Item Name: Floor Protector - Passenger Cabin

DART SERVICE INSTRUCTION

TO AMEND INSTALLATION INSTRUCTIONS IIN-D407-781-1 REV E AND INSTRUCTIONS FOR CONTINUED
AIRWORTHINESS ICA-D407-781 REV 4

REF CANADIAN STC: SH08-60
FAA STC: SR02726NY
EASA STC: EASA.IM.R.S.01541

FIGURE 1: FLOOR PROTECTOR INSTALLATION

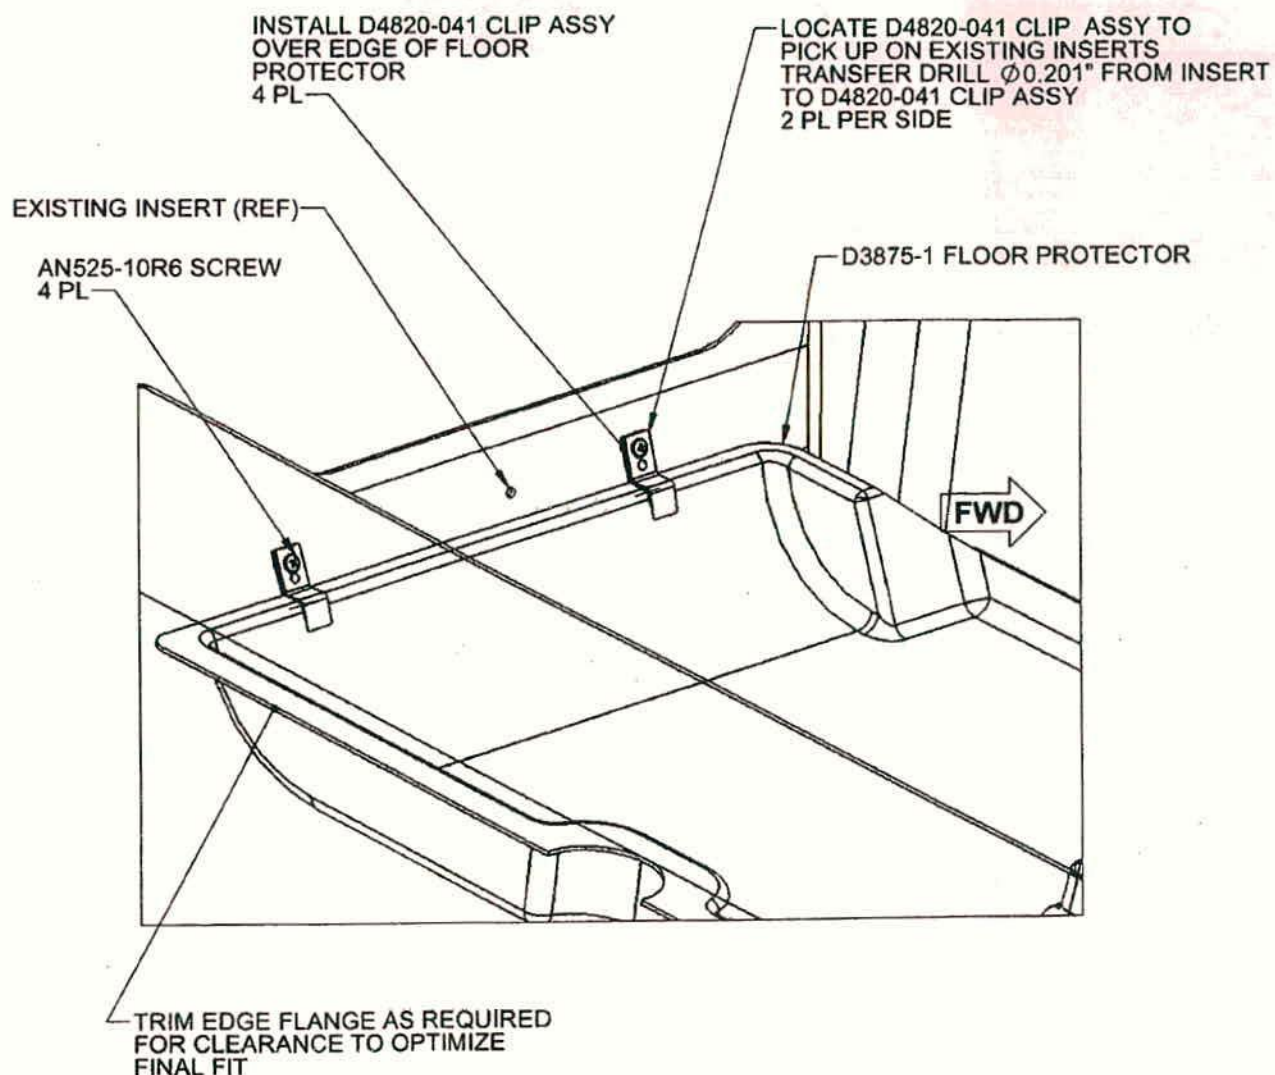
The purpose of this Dart Service Instruction (DSI) is to provide an alternate method of installing the D206-781-021 Floor Protector Kit when it is installed on aircraft without carpets.

- 2.1 Position the D3875-1 Floor Protector in the passenger area, trimming the edge flanges, as required, for clearance around obstacles and/or to optimize the fit. Ensure there is no debris beneath the protector.

- 2.2 Select the best positions for the D4820-041 Clips to pick up on the existing inserts (2 per side). Press down firmly on the floor protector to ensure it is in full contact with the aircraft floor and transfer mark the hole locations to the D4820-041 Clips.

- 2.3 Drill out the marked holes to $\varnothing 0.201$ and deburr.
- 2.4 Install the D4820-041 Clips (2 per side) using AN525-10R6 screws and secure the D3875-1 Floor Protector. The flat portion of the D4820-041 Clip Assy should slip behind the D3875-1 Floor Protector. Torque the screws to 15-25 in-lbs (1.7-2.8 N-m).

Qty -021	Part Number	Description
X	D206-781-021	FLOOR PROTECTOR KIT (PASSENGER CABIN)
1	D3875-1	FLOOR PROTECTOR, PASSENGER
2	D3934-041	CLIP ASSY
4	D4820-041	CLIP ASSY
4	AN525-10R6	SCREW
2	D3800-1-100-500	LOOP STRIP
2	D3800-3-100-500	HOOK STRIP

Qty -021	Part Number	Description
X	D206-781-021	FLOOR PROTECTOR KIT (PASSENGER CABIN)
1	D3875-1	FLOOR PROTECTOR, PASSENGER
2	D3934-041	CLIP ASSY
2	AN525-10R6	SCREW
2	D3800-1-100-500	LOOP STRIP
2	D3800-3-100-500	HOOK STRIP
